Intel[®] Mobile Celeron[™] Processor at 466 MHz, 433 MHz, 400 MHz, 366 MHz, 333 MHz, 300 MHz, and 266 MHz Specification Update

Release Date: June 2000

Order Number: 244444-015

Figure 2. Workaround Flowchart: SMBALERT#-Driven System

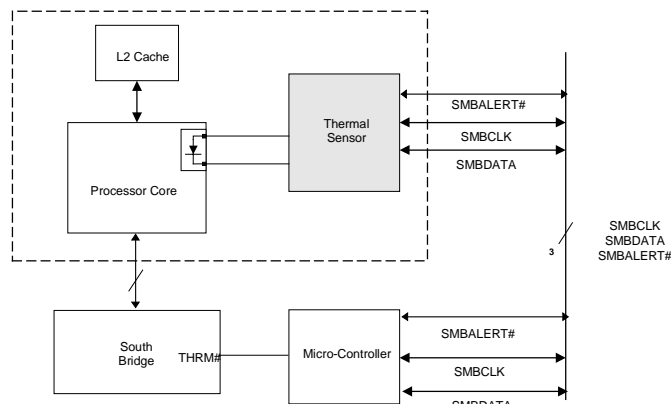
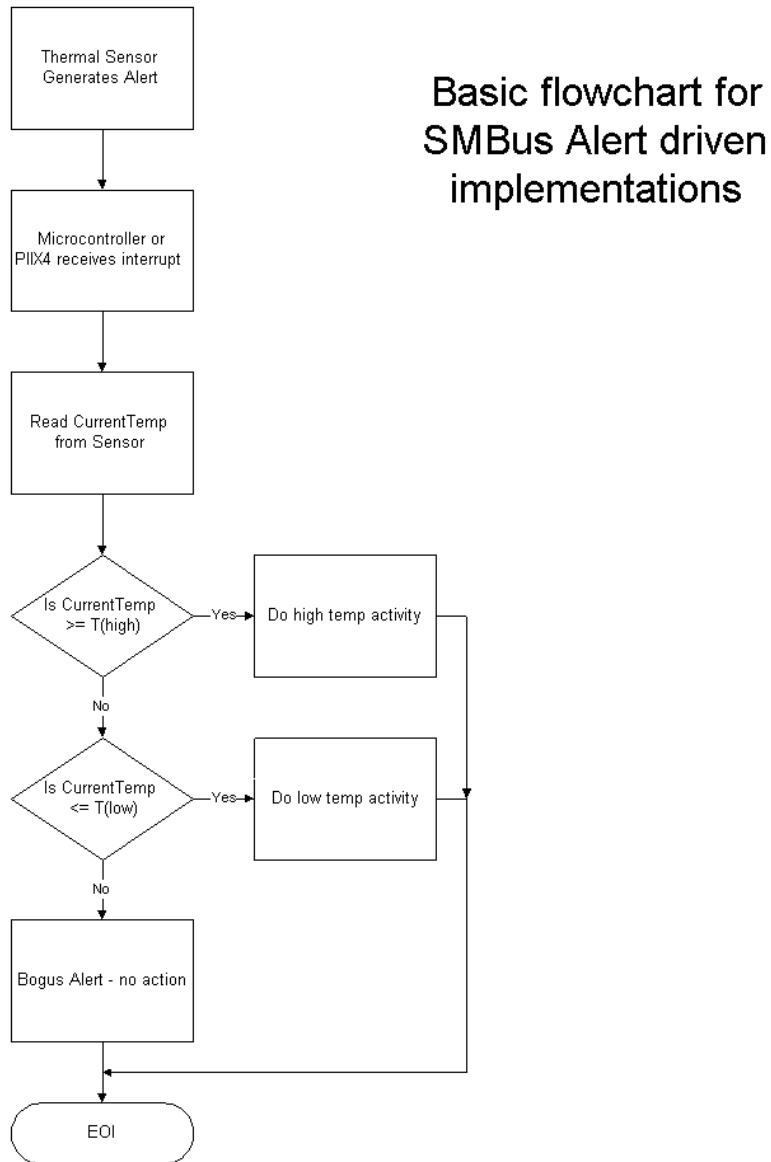
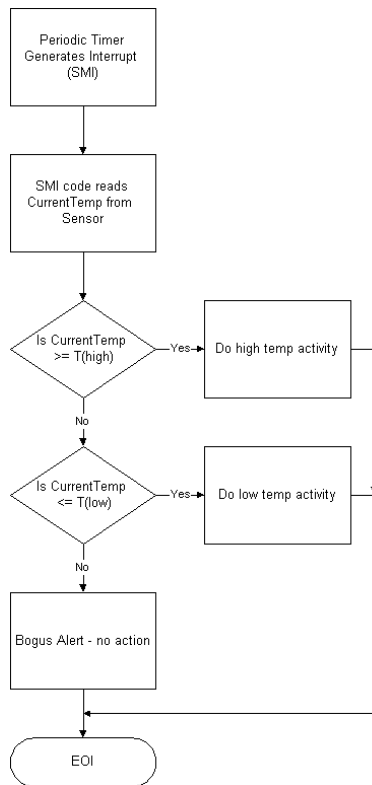
H29. Thermal Sensor May Assert SMBALERT# Incorrectly

Problem: The Intel Celeron Processor Mobile Module has a thermal sensor that monitors the processor core's temperature. Please note that desktop systems could have a similar thermal device. The thermal sensor asserts SMBALERT# if the processor temperature exceeds the temperature limits set in the Alarm Threshold Registers (T_{HIGH} , T_{LOW}). It also sets the corresponding Status Register bits to identify the cause of the interrupt. Figure 1 gives one example of the how the SMBALERT# signal could be used in a system.

Implication: There is no system impact from this erratum if temperature polling is used for processor thermal management. If the SMBALERT# interrupt is employed to manage processor thermal sensing, then servicing the false interrupt may result in premature system action depending on the software and hardware implementations used. The rate of the false interrupts is less than the auto-convert rate of the thermal sensor.

Workaround: Three different (mutually exclusive) workarounds are possible:

1. Before servicing an interrupt from the thermal sensor, read and compare the processor thermal reading with the threshold limits (T_{HIGH} or T_{LOW}). Figures 2 and 3 provide basic flowcharts for the implementation of this workaround in an interrupt driven system.
2. If the firmware implemented polls the Status Register only, then before taking any action, re-read the temperature register and do a comparison with the alarm threshold limits (T_{HIGH} or T_{LOW}) to determine if the value is actually still within the temperature window.
3. Use a temperature polling scheme to monitor the processor temperature.

Figure 5.3. Surface-Mount BGA1 Package—Top and Side View

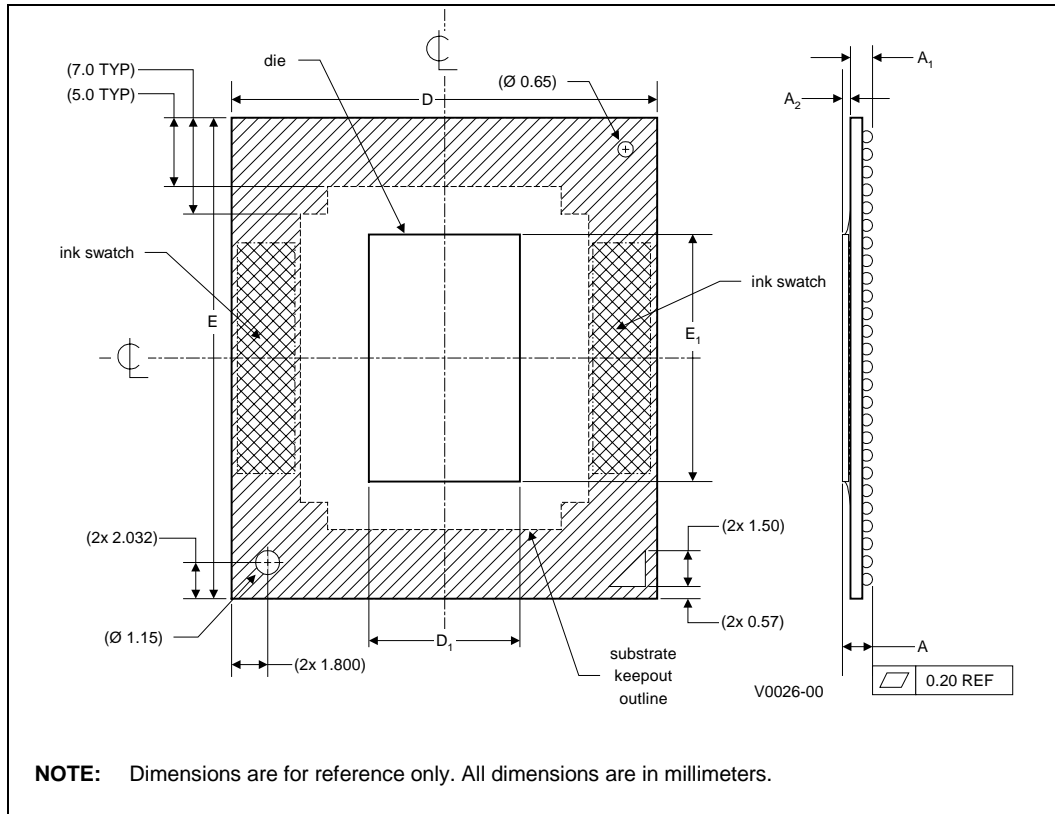
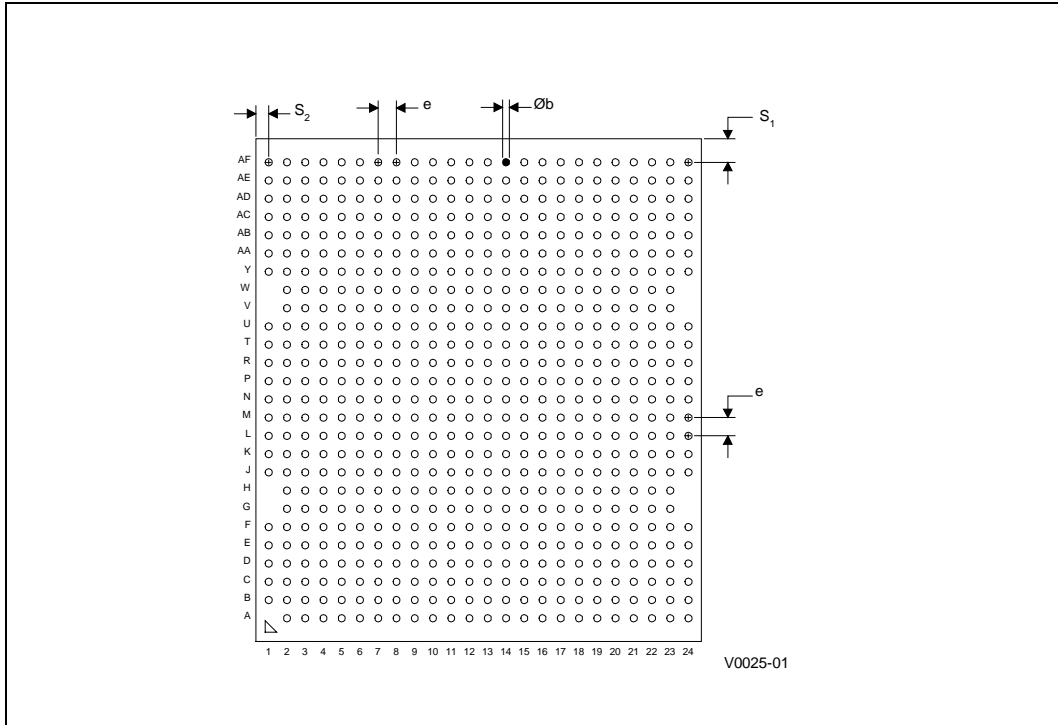
The following table and figures show the updated mechanical specifications for the BGA1 package, listed as Table 5.2, Figure 5.3 and 5.4, respectively, in the *Intel® Mobile Celeron™ Processor in BGA Package at 333 MHz, 300 MHz and 266 MHz* datasheet.

1. The number shown here is different from that in the 244444-004 version of this specification update. The maximum reference number is used.

Figure 3.3 Generic Clock Waveform

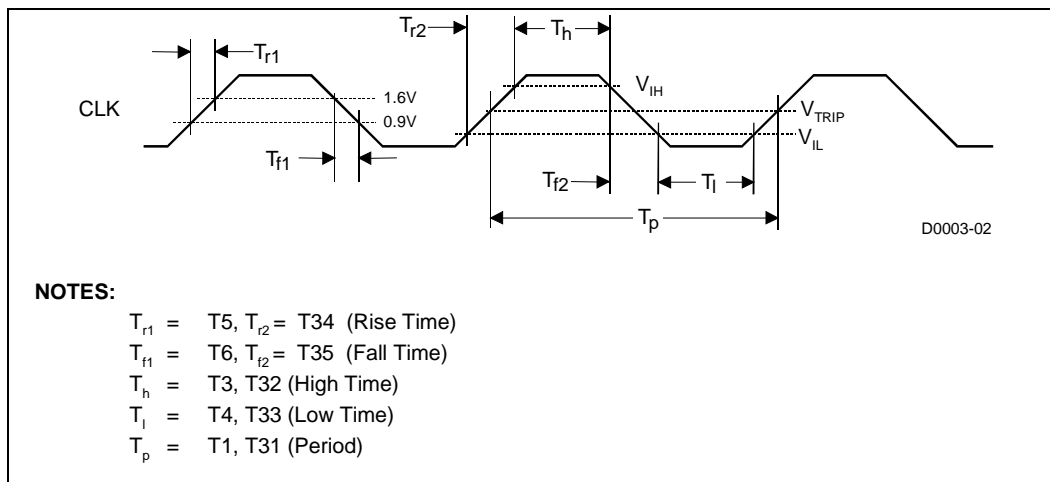
H11. Generic Clock Waveform Figure

Figure 3.3 in the *Intel® Mobile Celeron™ Processor in μPGA1 and BGA1 Packages at 366 MHz, 333 MHz, 300 MHz, and 266 MHz* datasheet (Order Number 245112-003) has been updated. The following figure is to replace the one in the above document.
